**RE: SUBMISSION: PROPOSED ZONING FOR STAGE 1 PLAN FOR THE
WESTERN SYDNEY AEROTROPOLIS**

The submission herein is made on behalf of Cornish Group in response to the draft Western Sydney Aerotropolis Stage 1 documents, published for exhibition at <https://www.planning.nsw.gov.au/Plans-for-your-area/Priority-Growth-Areas-and-Precincts/Western-Sydney-Aerotropolis>.

Figure 4: Excerpt from Guidelines for riparian corridors on waterfront land – NSW Department of Primary Industries Office of Water.

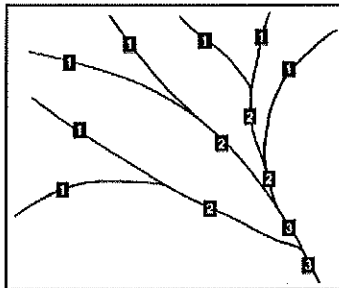
However, it is also noted, that as a 4th order stream, Cosgroves Creek will require a 40m Vegetated Riparian Zone to observe the guidelines for riparian corridors on waterfront land as prescribed by the NSW Department of Industries Office of Water (See Figure 4 below).

The application of the recommended riparian corridor widths shown in Figure 4 above to Cosgroves Creek, would provide a 100m wide corridor which we believe is more than sufficient to achieve the objectives of the waterway planning principles of Greater Sydney Commission’s Western City District Plan, noted above.

Moreover, implementing the guidelines along the creek would provide a core buffer/no disturbance zone of 20m in addition to a re-vegetated outer 20m on each side, accommodating cycleways, viewing platforms and BBQ areas for workers and the community.

Cornish Group therefore submits that a zoning classification of Water Management for such areas, would concurrently observe the Office of Water recommendations for riparian corridors and better achieve the objectives of the Greater Sydney Commission’s Western City District Plan.
